REVIEW COMMENTS

FILE RP-96-42

TITLE HEADING: Replat - Eagle Rim Subdivision

LOCATION: Mountain View Court

EAGLE RIM SUBDIVISION, GRAND JUNCTION, COLO.

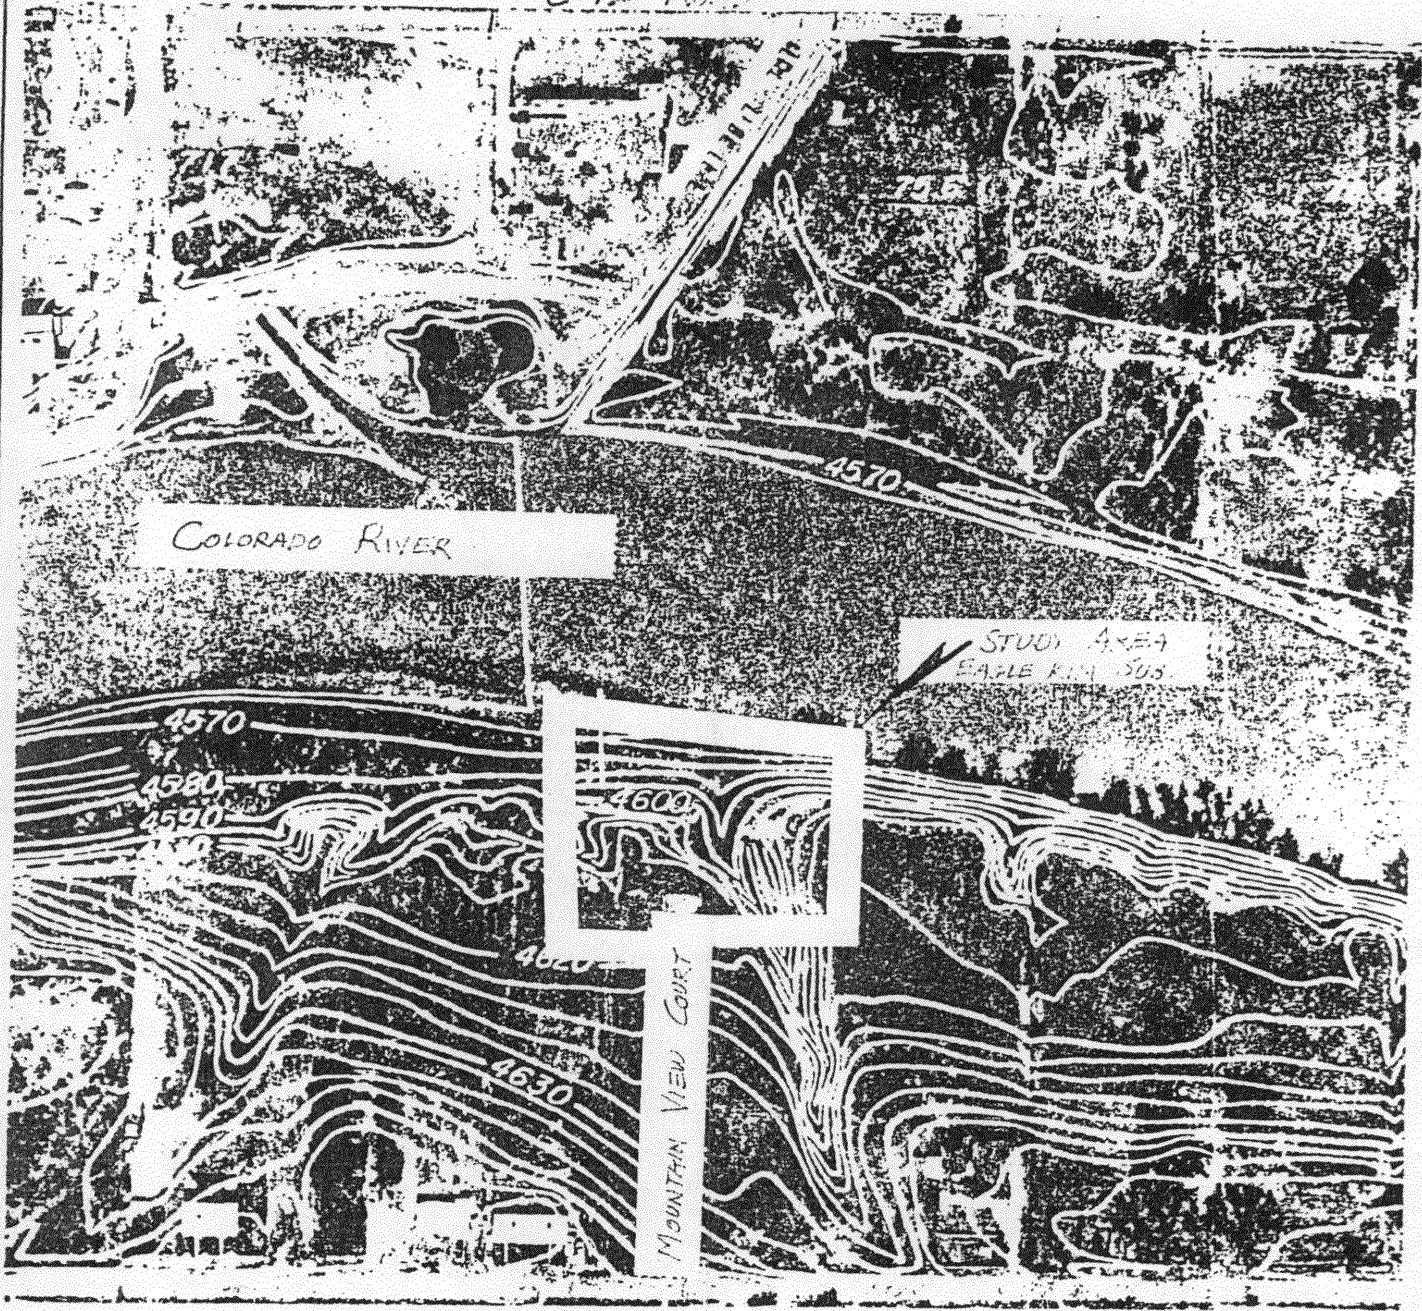
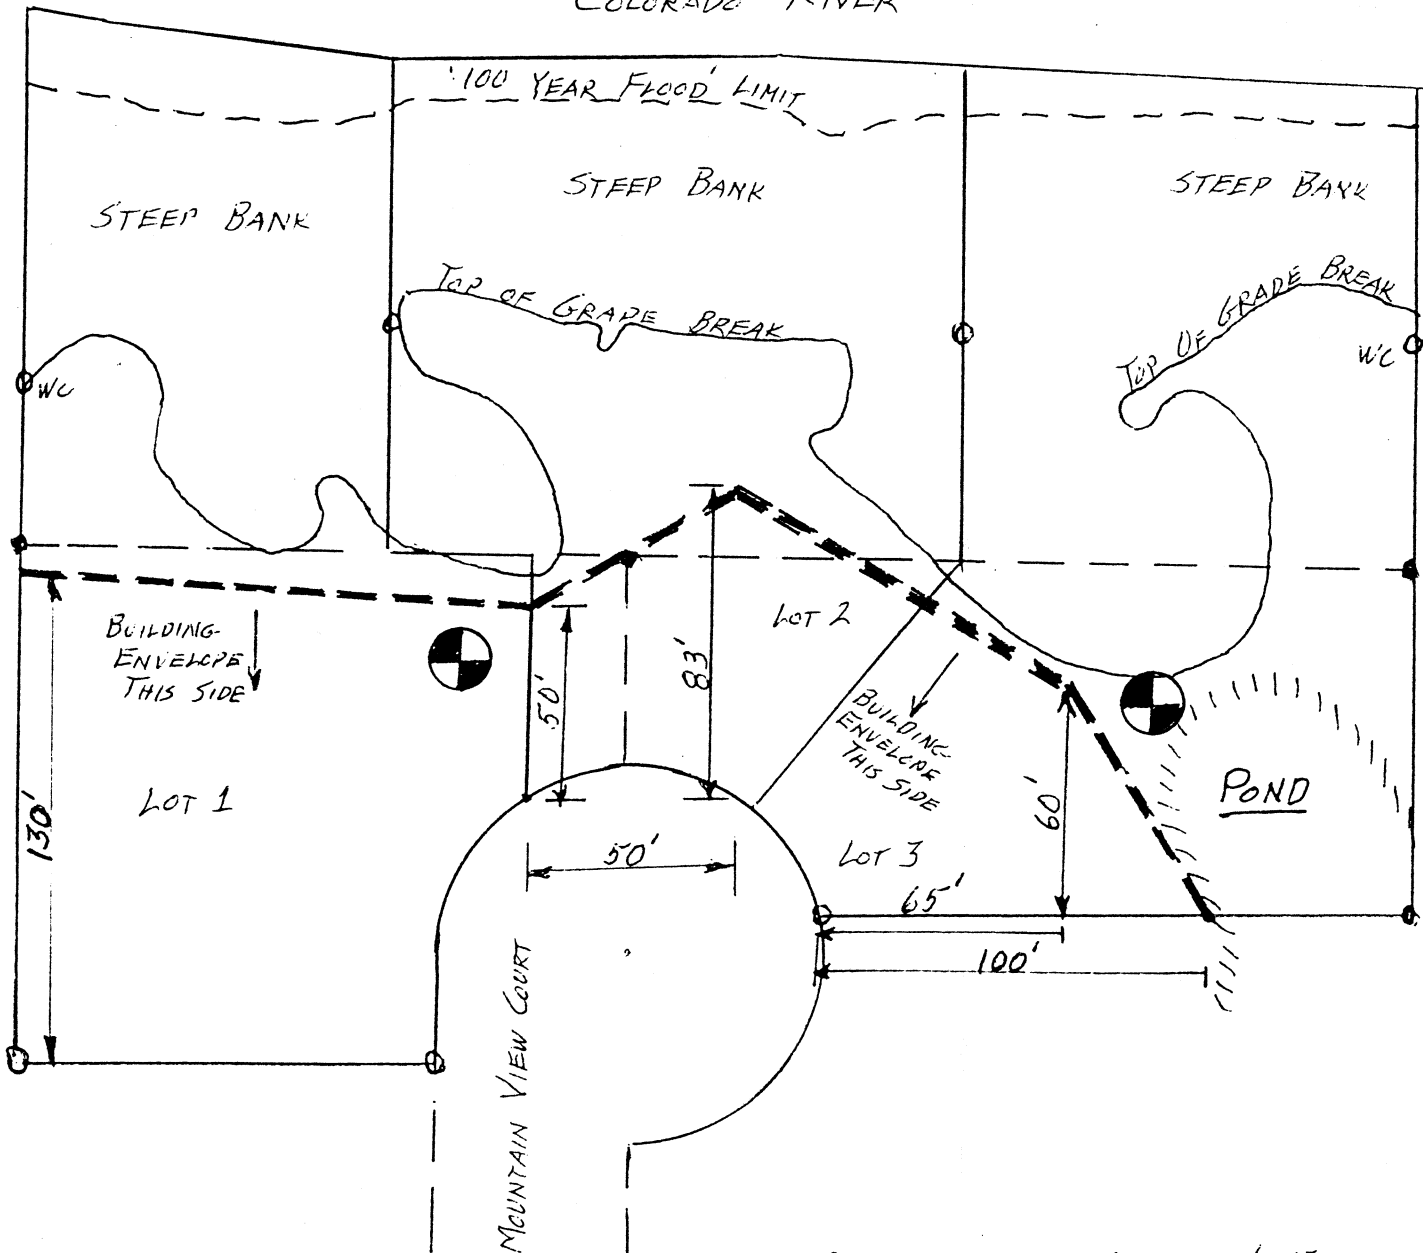
No geologic conditions were apparent during our reconnaissance which would preclude the site development as planned, provided the recommendations contained herein are fully complied with. Based on our investigation to date and the knowledge of the proposed construction, the site condition which would have the greatest effect on the planned development is the very steep banks overlooking the Colorado River, with the recommendation to restrict construction to South of the building setback line, shown on the attached figure.
